**CULTURAL RESOURCES OFFICE
 PRESERVATION BOARD
 REGULAR MEETING
 MONDAY DECEMBER 16, 2012 — 4:00 P.M.
 1520 MARKET ST. #2000
www.stlouis-mo.gov/cultural-resources**

DATE: December 16, 2013
ADDRESS: 4643 Lindell Boulevard
ITEM: Preliminary Review: Demolish an office building and construct a 12-story residential building with street-level retail space.
JURISDICTION: Central West End Certified Local Historic District — Ward 28
STAFF: Betsy Bradley, Cultural Resources Office

DATE: December 16, 2013
ADDRESS: 4243 Maryland Avenue
ITEM: Preliminary Review: Construction of a new single-family house.
JURISDICTION: Central West End Historic District — Ward 18
STAFF: Jan Cameron, Cultural Resources Office

DATE: December 16, 2013
ADDRESS: 3011 McNair Avenue
ITEM: Preliminary Review: construction of a new single-family house
JURISDICTION: Benton Park Local Historic District — Ward 9
STAFF: Jan Cameron, Cultural Resources Office

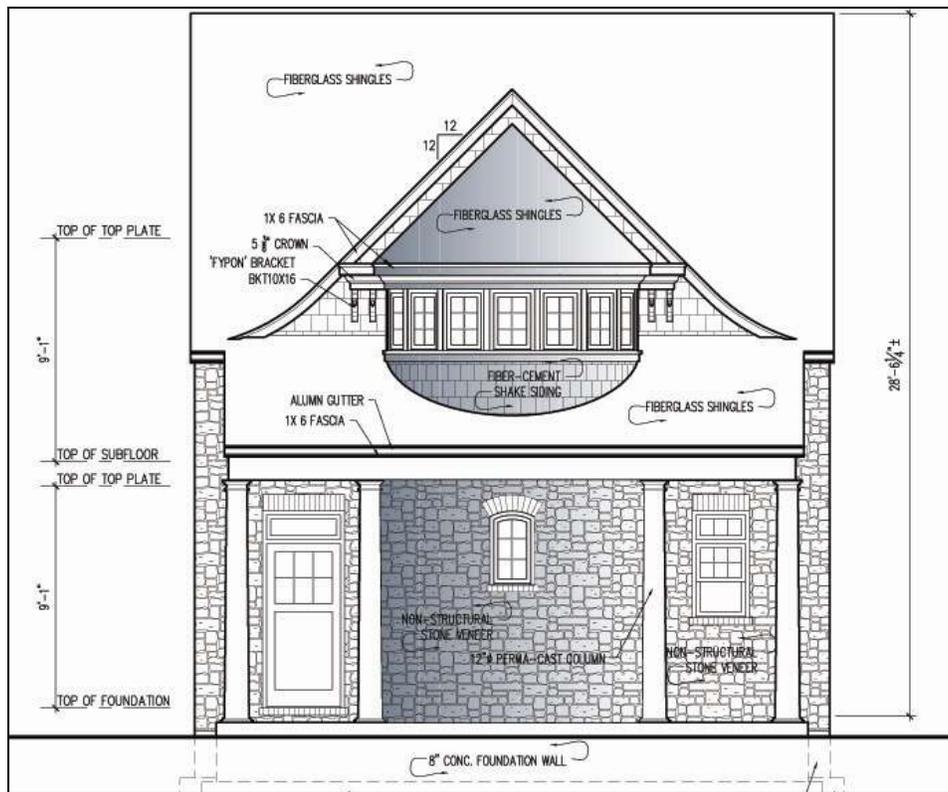
Does not comply. The design of the proposed house does not refer to any of these required elements. It is uncharacteristic in total height and floor-to-ceiling heights; the building is slab-on-grade, with no exposed foundation or watertable.

Does not comply. The house's siting is intended to mimic a carriage house and is located at the rear of the property, approximately 12 feet from the alley and 166 feet back from the street. There are no adjacent ancillary buildings and therefore the building cannot be assessed in terms of existing rhythms or façade widths.

Appears to comply. The front elevation is proposed to be a stone veneer and the rest of the building brick. Several stone-fronted brick buildings are extant on the street. At this time, the design of the stone, its coursing and joint profile, has not been submitted for staff review, but is intended to duplicate the historic stone facades.

Partly complies. While the windows on the front elevation are doublehung, they are smaller than is typical of the block and the total area does not approach the required 10% of the window area of other buildings.

Based on the preliminary findings, the Cultural Resources Office recommends that the Preservation Board grant preliminary approval for the proposed new construction, as its location far to the rear of a narrow lot will have little effect upon the streetscape. However, the staff recommends that as a condition of this approval, the owner be required to erect appropriate fencing and/or landscaping at the building line to continue the line of the street, and that final drawings and exterior materials be approved by the Cultural Resources Office.

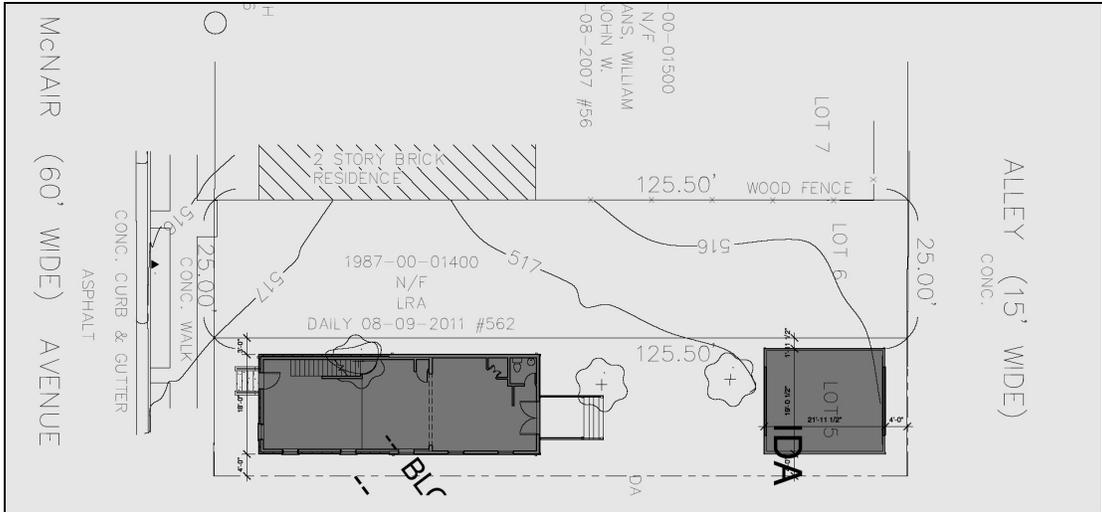
- The proposed site for construction, 3011 McNair, is located in the Benton Park Local Historic District.
- The project is proposed to be constructed directly to the north of a new two-story, single-family house by the same developer, at 3015 McNair, which was approved by the Preservation Board at its November meeting.
- The proposed massing, scale, proportions and detailing of the building are appropriate for its site and compatible with adjacent buildings and follow the Model Example.
- The north elevation will be somewhat exposed to street view due to the width of the side yards between the new building and 3009 McNair.

That preliminary approval be granted subject to reconsideration of the design of the north elevation and to review of final details, materials and drawings by the Cultural Resources Office.

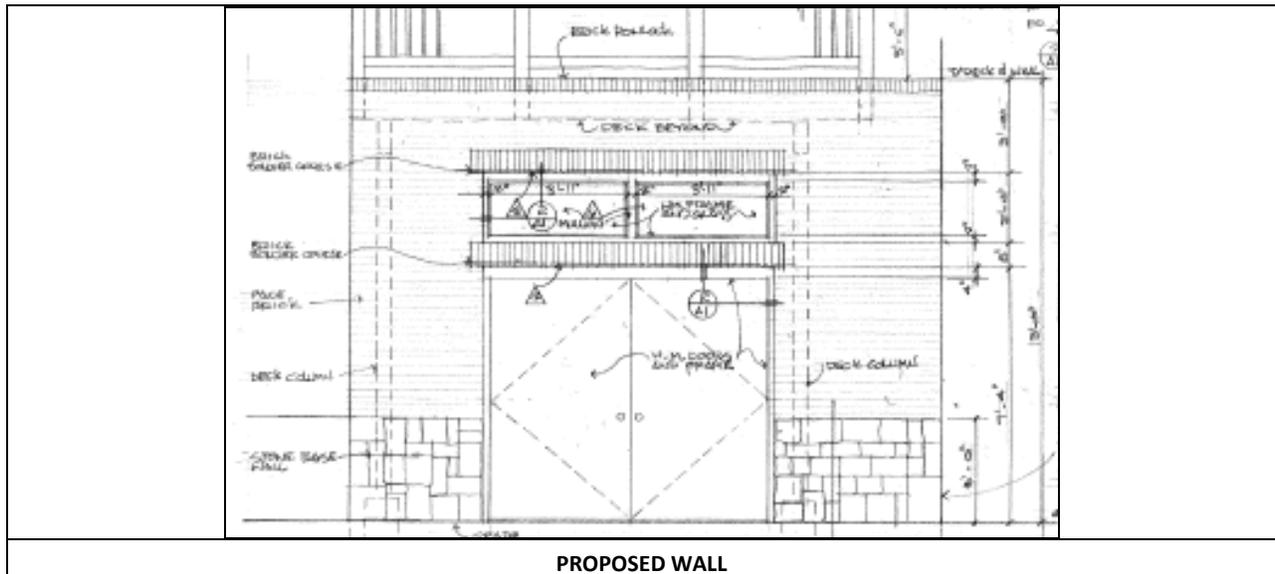
Does not comply. If the project is considered to be a landscaping wall, it would not be compliant as it is proposed to be 13 feet tall, well over the allowed height under the standards. If the project is considered to be a fence, it does not conform to the standards because it is too tall and the overall design is not based on a Model Example. The proposed doors and transom would not be found in any Model Example and are not appropriate for a fence. Although the wall is located on an alley, it is highly visible from the street. The wall is out of scale and not an appropriate design for the historic district.

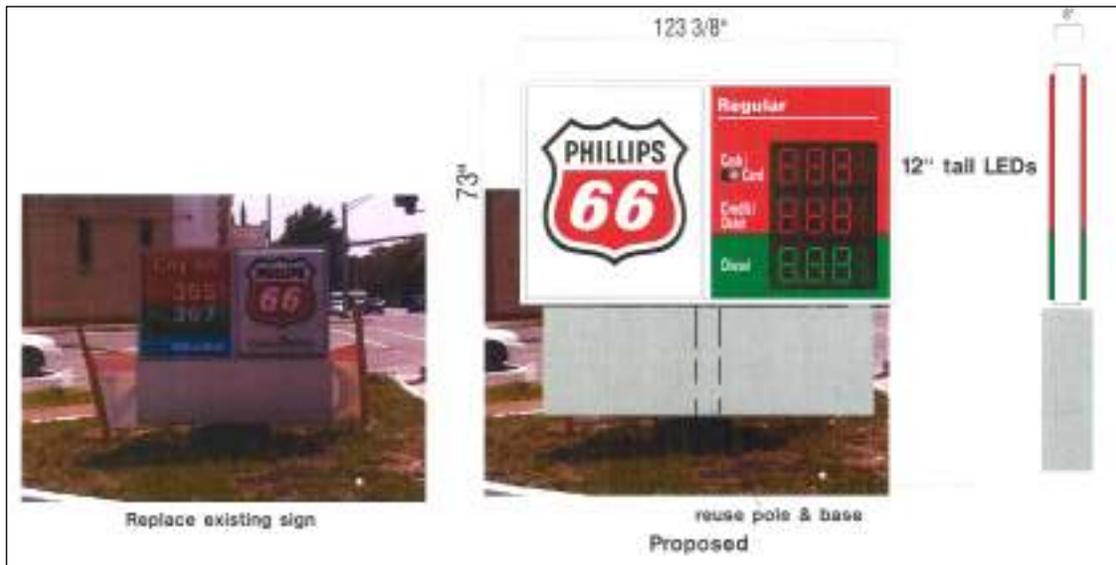
Complies. Although the numbers will occasionally change, they are static.
